UNITED STATES PATENT AND TRADEMARK OFFICE

Office Action Summary

10/527,935

DRABAREK ET AL.

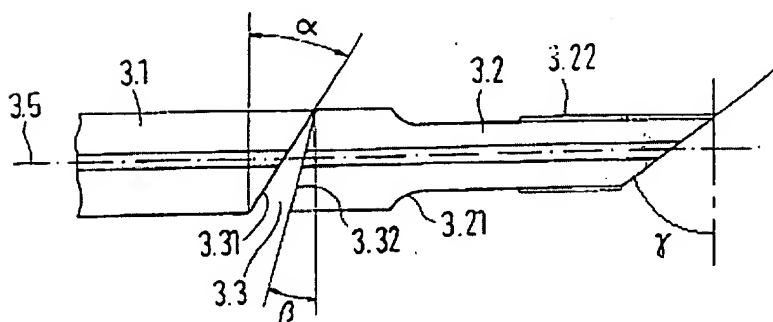
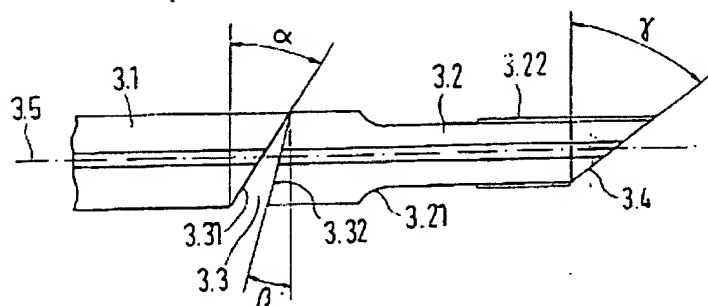
- a. The recitation of "an angle of inclination of the exit surface to the normal of an optical probe axis of the probe-optical fiber unit" in claim 11 is indefinite. The recitation is indefinite in that there are at least two possible ways of determining the claimed angle as shown in the figures below:

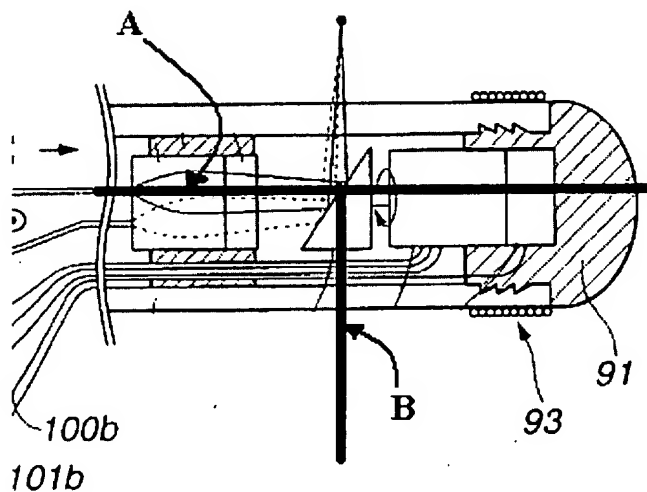
- c. The recitations “slantwise” in claim 1 and “jacket-like” in claim 13 are indefinite.
3. Claims 11-20 are rejected under 35 U.S.C. 112, second paragraph, as being incomplete for omitting essential structural cooperative relationships of elements, such omission amounting to a gap between the necessary structural connections. See MPEP § 2172.01. The omitted structural cooperative relationships are: There are multiple axis of a probe, and the claim does not specify clearly which is being referred to. There is at least an axis along the length of the optical fiber and there is an axis for the exit of the probe. Please see the figure below showing the axis (A) along the length of the optical fiber and an axis (B) for the beam at the exit of the probe of a prior art.
